Permit Number: 030643

This is to certify that A G Car Co/Wright Ryan Construction,  
has permission to 27 housing units; Construction of 3.5 stories addition on top of existing parking structure.. Project consists of mi  
AT 41 State St 044 B023001

Subject: Casco Terrace  
41 State Street  
Portland, ME

**RE: 41 State Street - Casco Terrace**

| SK6 | PART SITE PLAN | Rev. 01. 2003 | Project:                            | CASCO TERRACE   | ARCHETYPE, P.A.<br>ARCHITECTS | Developer: | MAINE WORKFORCE<br>HOUSING, LLC |

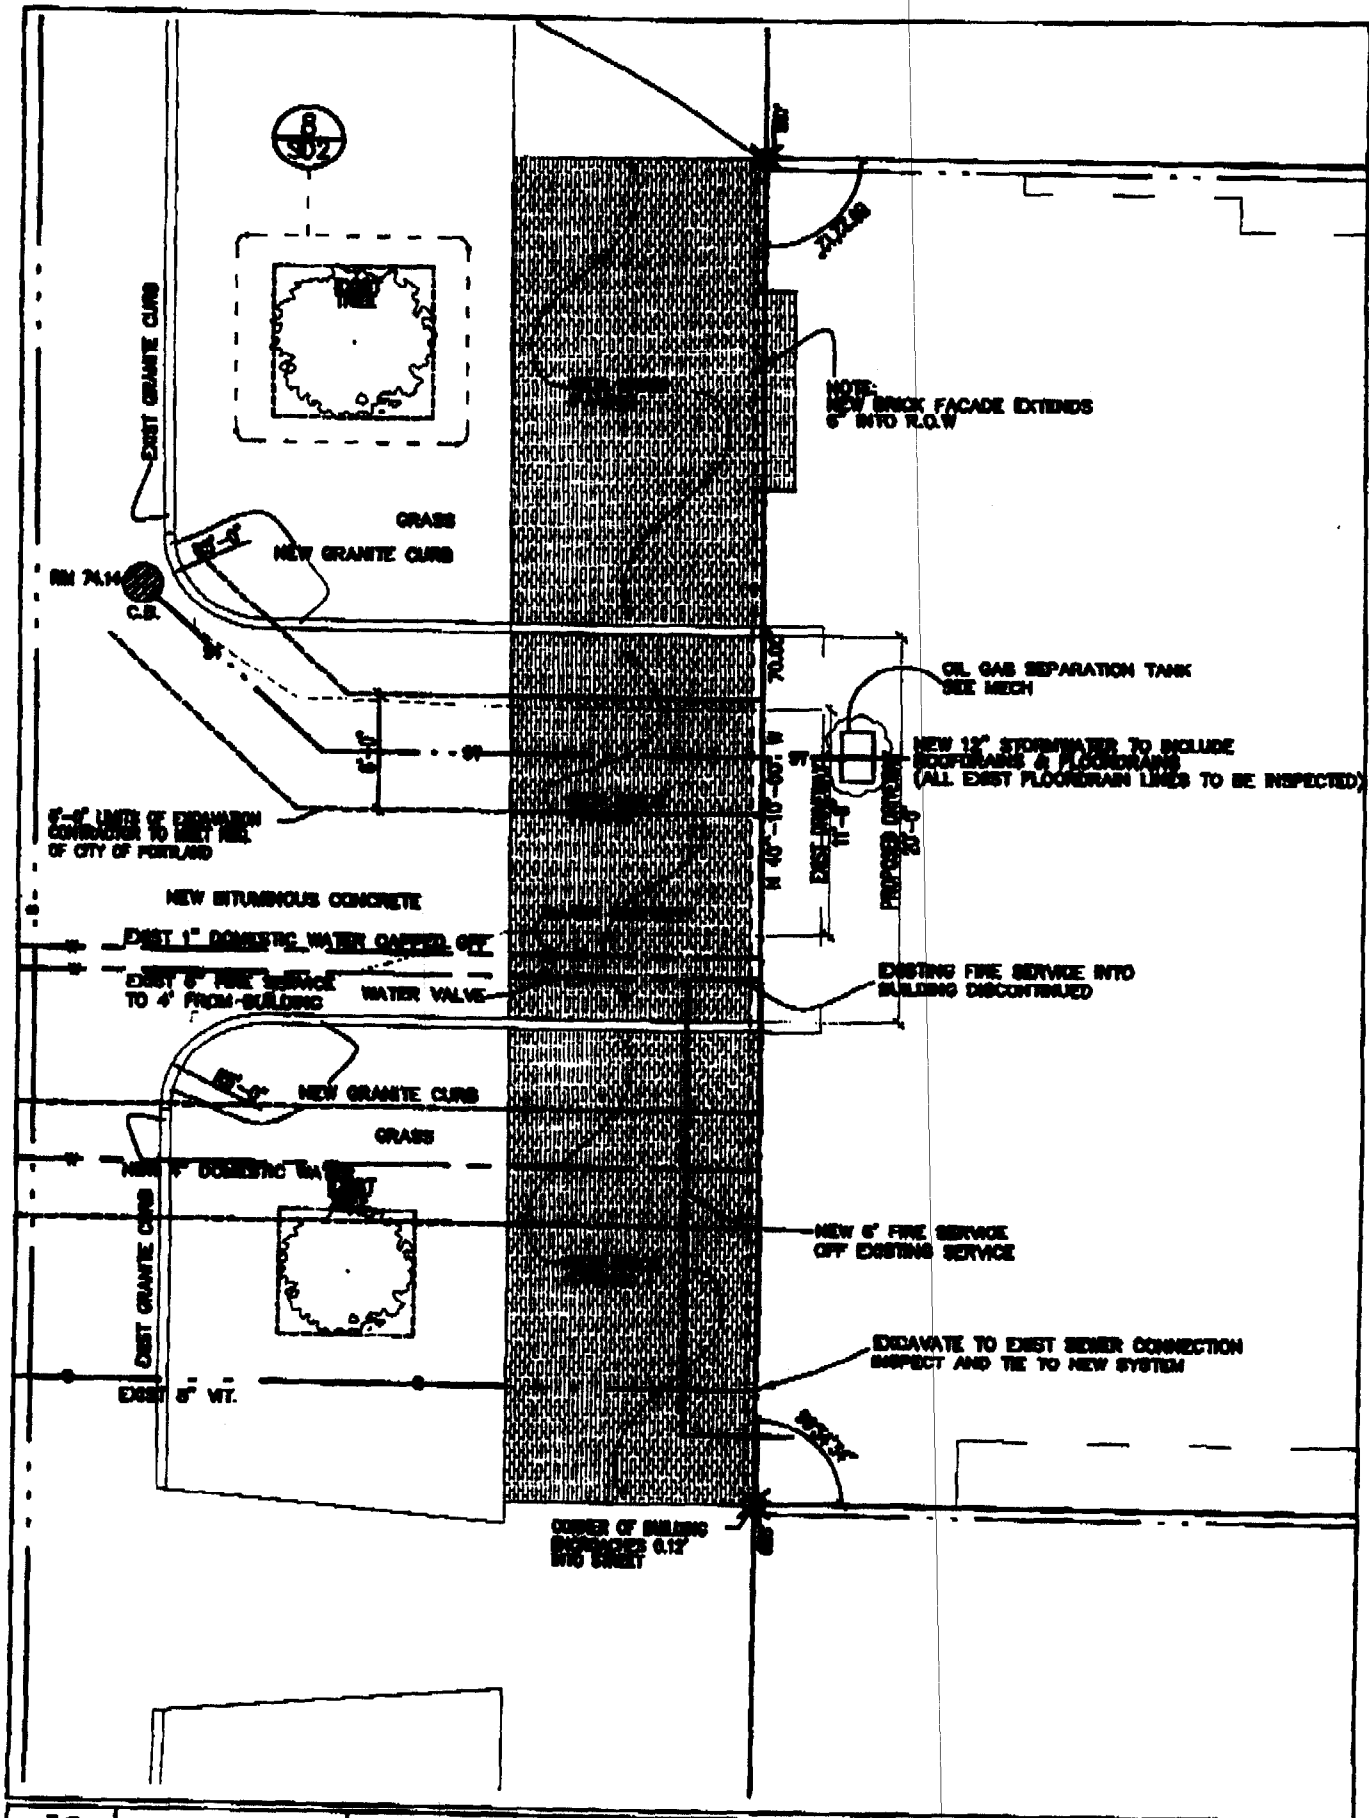
Attached is SK 6 showing that we have moved the oil gas separation tank into the building and off city property.
